**TOWN OF LOS GATOS
PLANNING COMMISSION AGENDA
AUGUST 26, 2026
110 EAST MAIN STREET
TOWN COUNCIL CHAMBERS
7:00 PM**

- [6.](#) Consider a Request for Approval to Construct a New Second-Story Addition to an Existing Single-Family Residence on Nonconforming Property Zoned R-1:8. **Located at 193 Howes Drive**. APN 527-43-021. Architecture and Site Application S-26-007. Categorically Exempt pursuant to the California Environmental Quality Act, Section 15301: Existing Facilities. Property Owner: Neeraj Goel. Applicant: Laura Cuda. Project Planner: Suray Nathan.

- [7.](#) Consider an Appeal of the Community Development Director Decision to Approve a Request to Construct a Second-Story Addition Exceeding 100 Square Feet to an Existing Single-Family Residence on Property Zoned R-1:20:PD. **Located at 695 Bicknell Road**. APN 407-03-006. Minor Residential Application MR-26-001. Categorically Exempt Pursuant to the California Environmental Quality Act (CEQA) Guidelines, Section 15301: Existing Facilities. Property Owners: Ronald C. Eddington Jr. and Marjorie Eddington. Applicant: James Heck. Appellant: Dale Drumm. Project Planner: Sean Mullin.

Rear elevation on which the recommendation was made (Before)

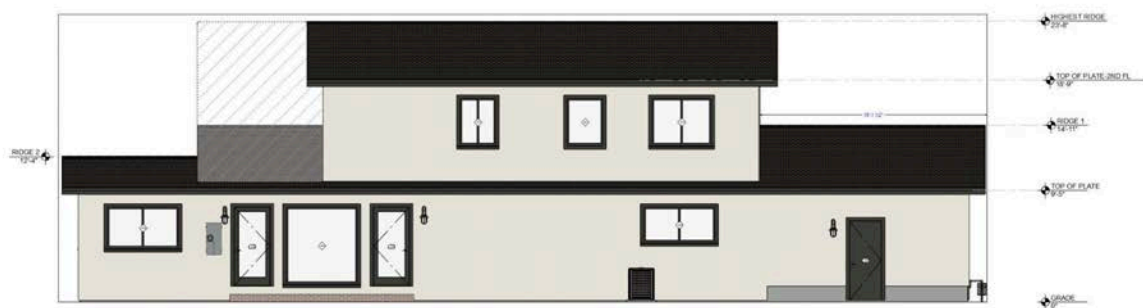
3.2 Wall Relief — Residential Design Guidelines Section 3.3.3

Rear elevation with the extended eave and roof to break up the wall (Now)

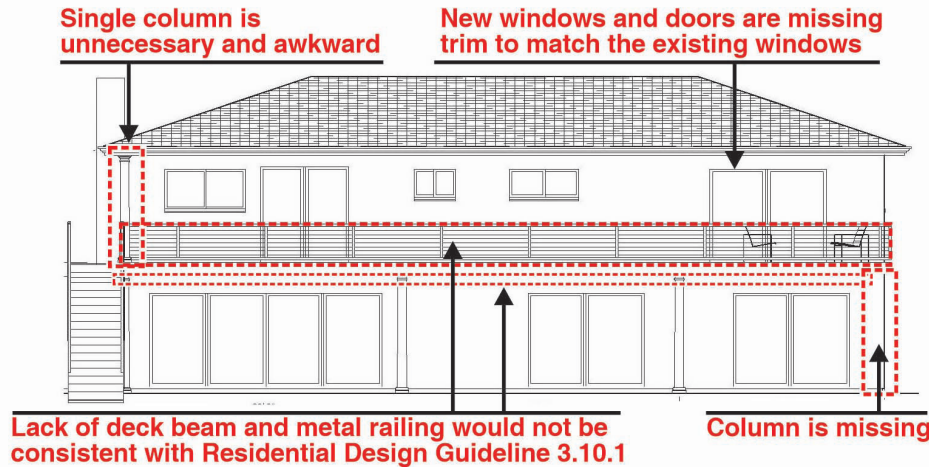
Unclear what happens in this area
Second floor plan says open to below but there is no outside wall shown

1. There is something missing and not coordinated at the second floor addition over the home entry. The floor plans call for an open space to the floor below but does not show an exterior wall. **Ans: The plans have been corrected to fix this on sheet A-2 and A-4.**

APPROACH A

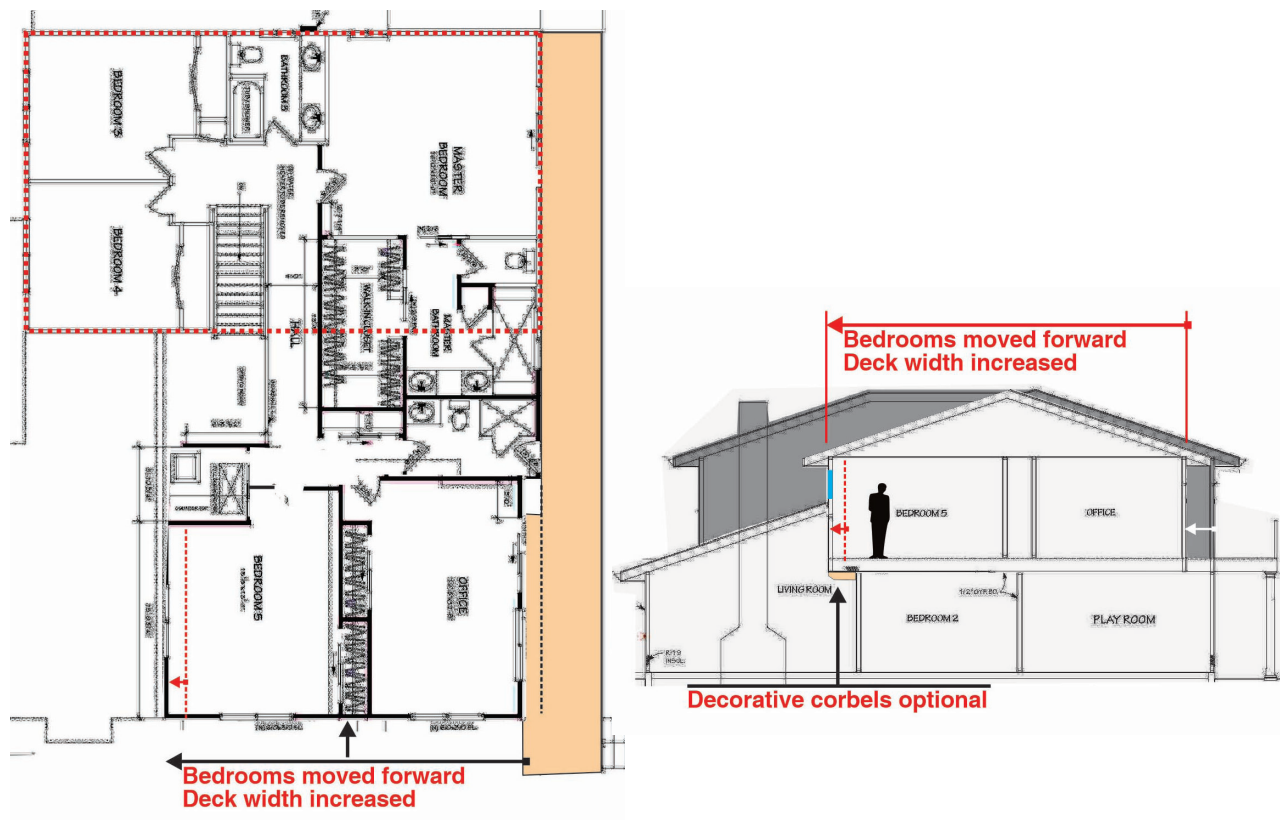
The simplest approach would be to shift Bedroom 5 and the office a bit toward the home frontage so that the first floor roof peak would hit the wall plane, eliminating the roof drainage toward the building face and maintaining the proposed windows. This is shown in the plan and section illustrations below. An option would be to retain the rear wall at the office in alignment with the adjacent rear wall by increasing either the depth of Bedroom 5 or the office.

The downside of this approach as shown is that a portion of the second floor Bedroom 5 volume would intrude into the first floor elevated ceiling space.

Applicant's response: After review of the two options provided by Larry at CDG, we have decided that option "A and B" would cause structural changes and modify the lower living room ceiling. However, we have changed the design to extend the existing roof to the new exterior wall for better weather proofing. Changes to sheets A-2 and A-4 as windows sizes have been reduced.

Staff analysis: The development plans were revised to extend the existing roofline to meet the second-story addition, as shown in the section drawing on Sheet A-2.

APPROACH B

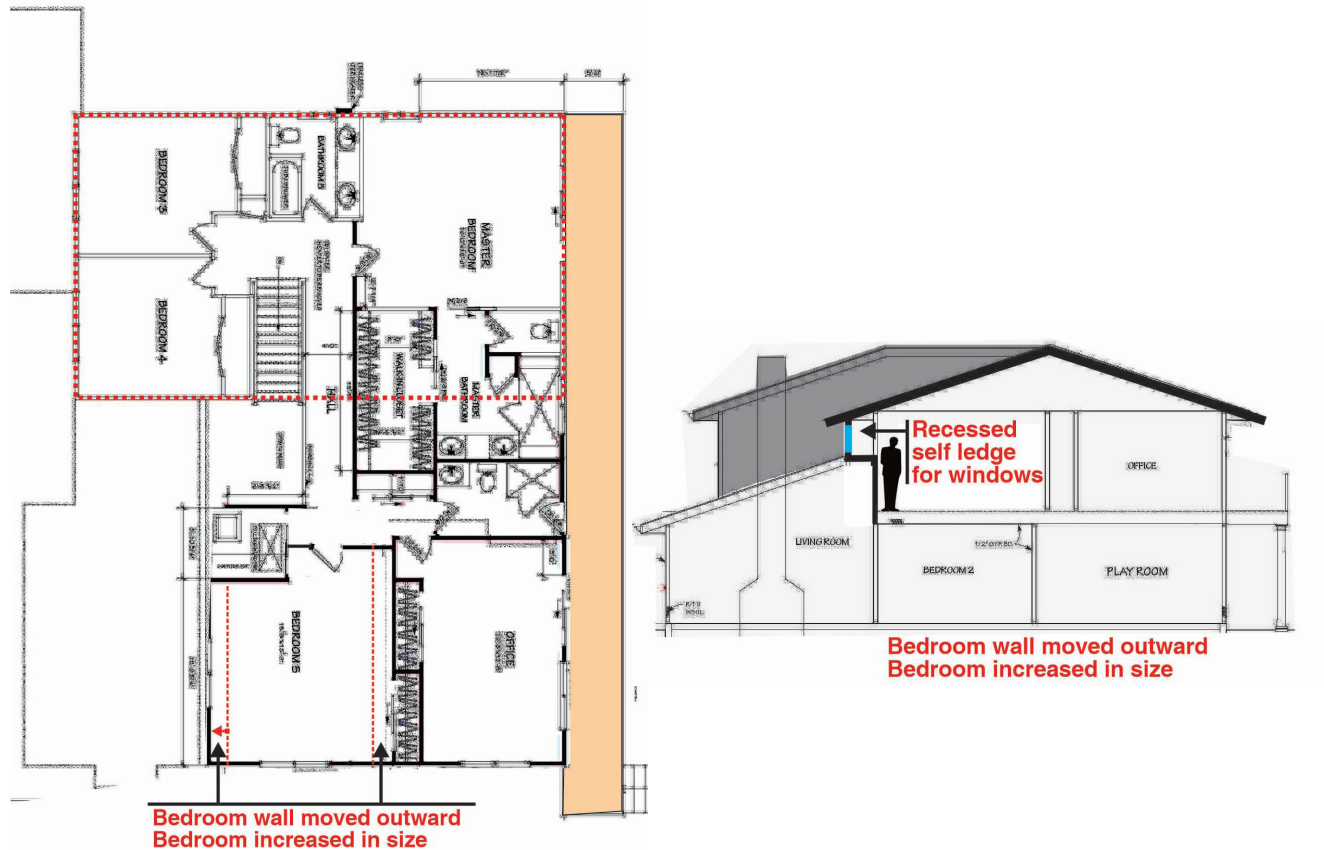
A similar approach that would leave the first floor Living Room volume untouched looks awkward in section but would be a simple fix. It would align the Bedroom 5 wall with the Living Room wall below and add an extended window ledge to bring a wall facade out to match the first floor roof ridge.

The applicant should be asked to explore other approaches but in the end it is probably their choice to make.

REVISED ELEVATION WITH 2ND STORY SETBACK
2 TO 3 FEET

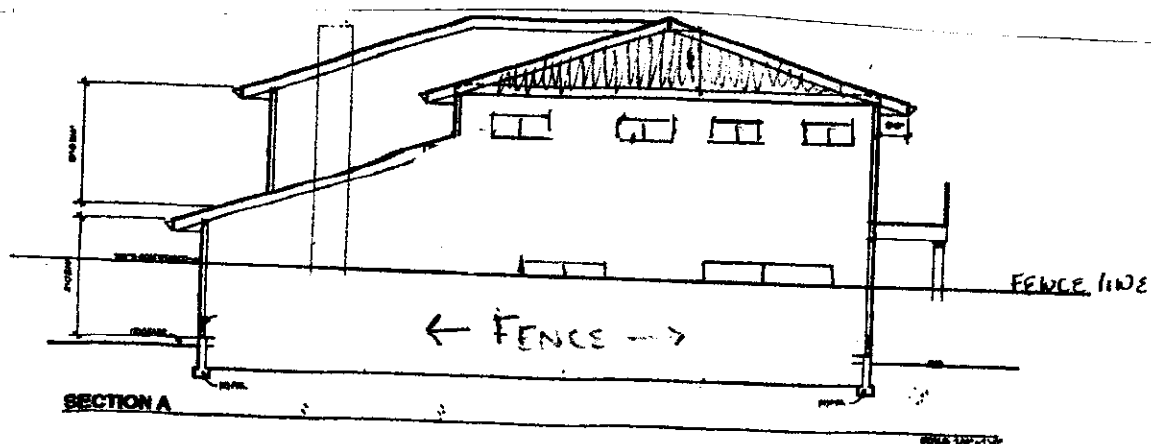
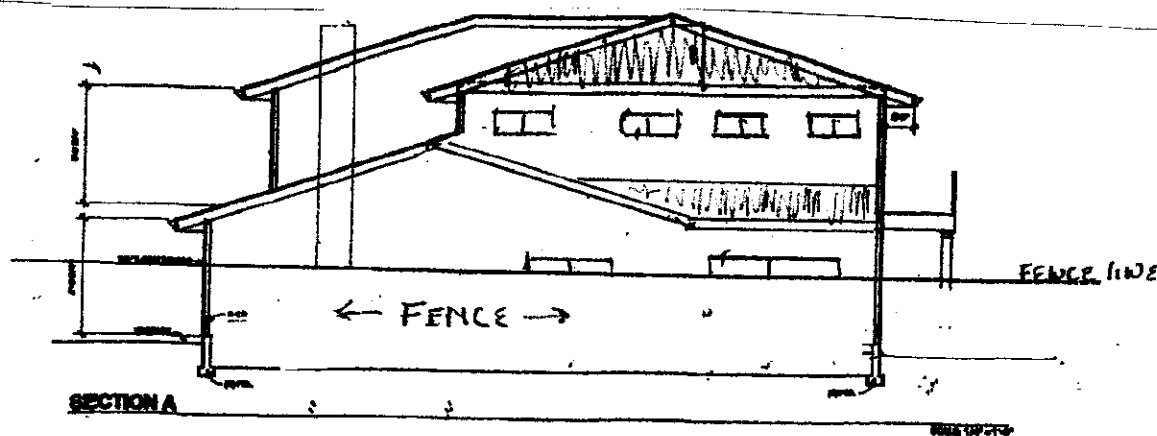
and features, so it is at least pleasing to look at on a daily basis. The rooms that would be affected by this change to the second story would be the office and bedroom #5. Any reduction in room size would not significantly disrupt the use of the rooms especially with all the other rooms within the existing and proposed home. The Town's own Residential Design Guidelines Section 3.3.2 specifically recommends this technique to minimize the second-story visual impact. (Exhibit 11).

Staff Response: As detailed above, the Town's Consulting Architect reviewed the project and provided several recommendations to address its consistency with the Residential Design Guidelines (Exhibit 7). The Consulting Architect did not identify the two-story wall plane on the side elevation as a concern and did not provide a recommendation regarding this design feature. The applicant incorporated all of the Consulting Architect's recommendations into the project to the satisfaction of the Community Development Director. Additionally, in response to the appellant's concern, the applicant added trellises along the right-side elevation to break up the two-story wall plane. This approach is consistent with Section 3.3.3 of the Residential Design Guidelines.
